Title	09:25:05 Tue Jun 25 2002 Control Power Board	
Size D	Number	Rev F
Date 06/25/2002		David L. Huffman
Filename Blsctl.sch		Sheet 2 of 2

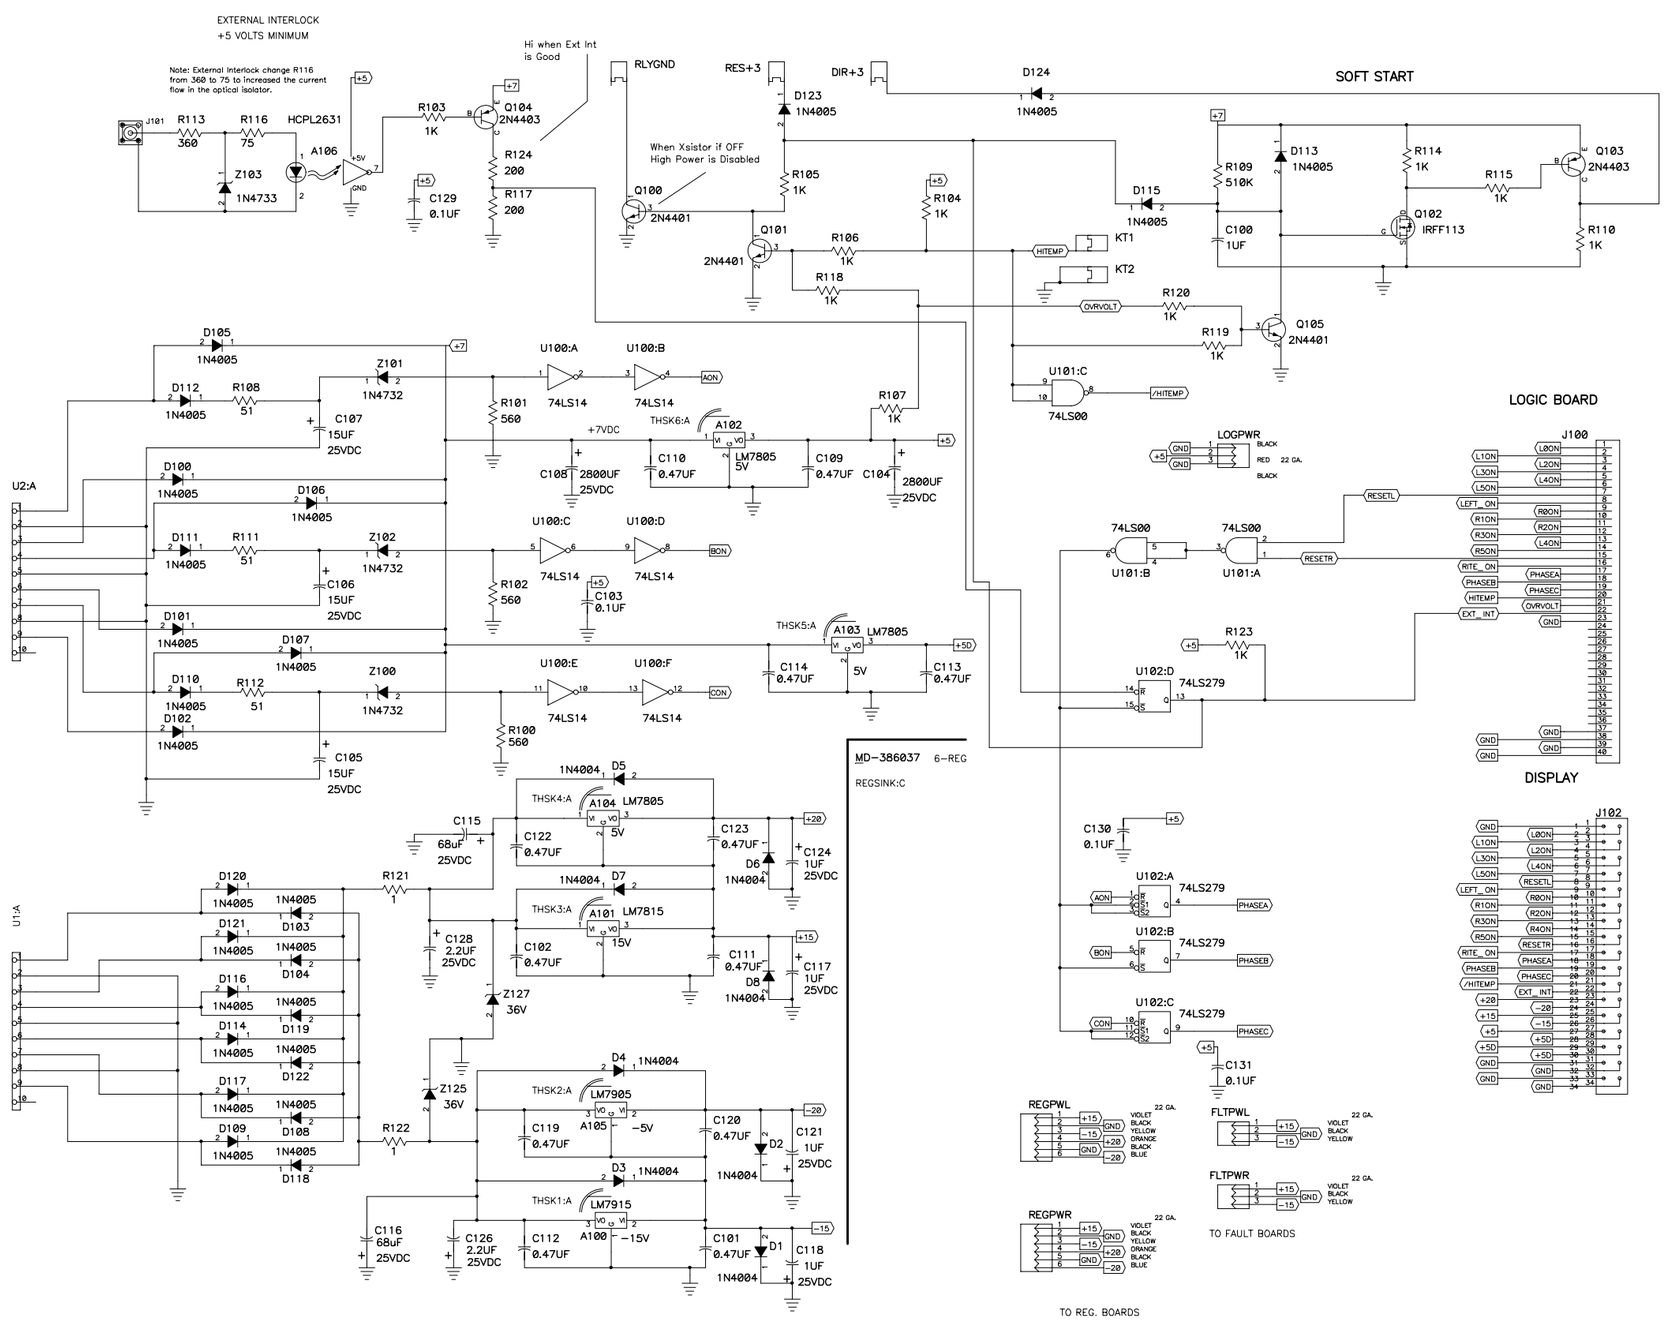
EXTERNAL INTERLOCK
+5 VOLTS MINIMUM
Note: External Interlock change R116 from 360 to 75 to increased the current flow in the optical isolator.
Hi when Ext Int is Good
When Xsistor if OFF High Power is Disabled
RLYGND
RES+3
DIR+3
SOFT START
LOGIC BOARD
DISPLAY
MD-386037 6-REG
REGSINK:C
LOGPWR
REGPWL
REGPWR
FLTPWL
FLTPWR
TO REG. BOARDS
TO FAULT BOARDS
Title 09:24:48 Tue Jun 25 2002
Control Power Board
Size D
Number 3740.412-ED-286060
Rev F
Date 06/25/2002
David L. Huffman
Filename Blsctl.sch
Sheet 1 of 2
